Statement

MAXON MX5010
FCC ID: AWWMX5010

Battery GDX2002

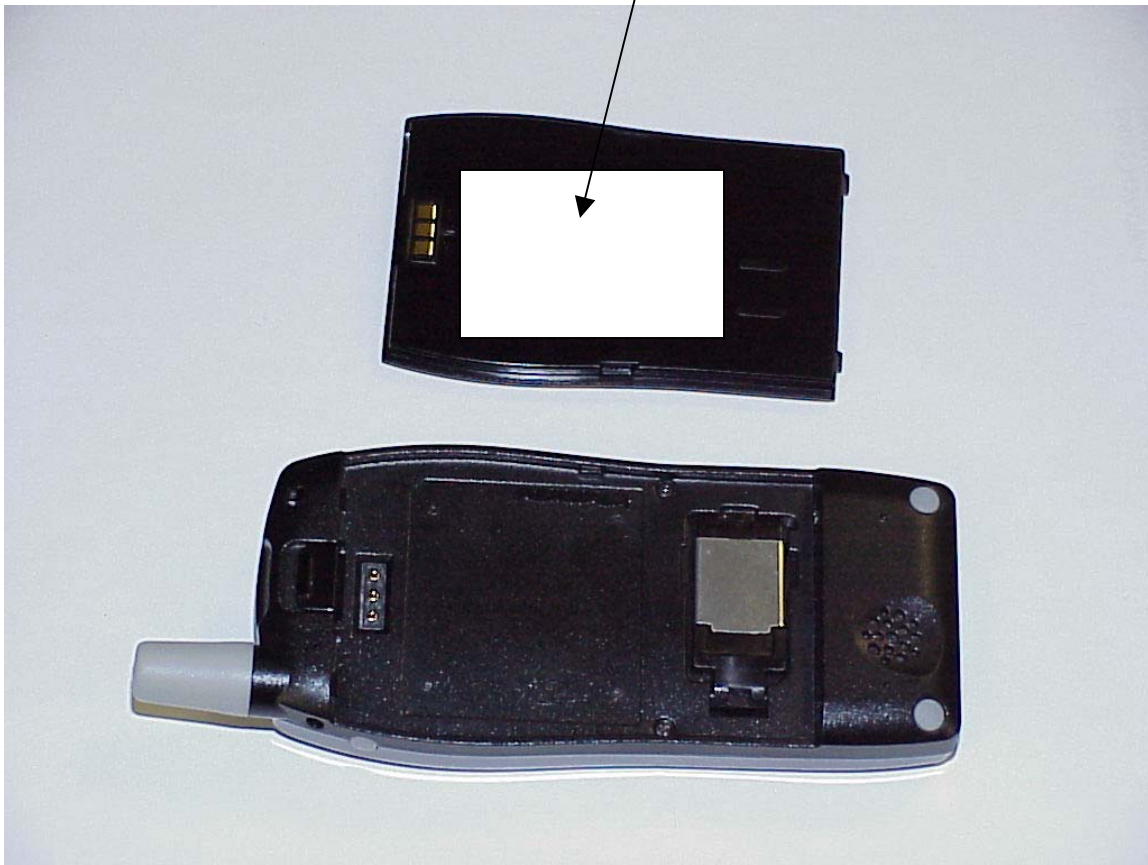
The statement about the identify of the phone especially point 5 regarding the battery.

The battery itself didn't change. What changed is the plastic, which was adopted to the shape of the phone. The black part in the battery picture shows the battery itself.

Battery itself is identical only the plastics around is adopted for design reasons. Location of the real battery.

The battery plastics follows now the shape of the phone were it was an rectangular insert in the previous version.
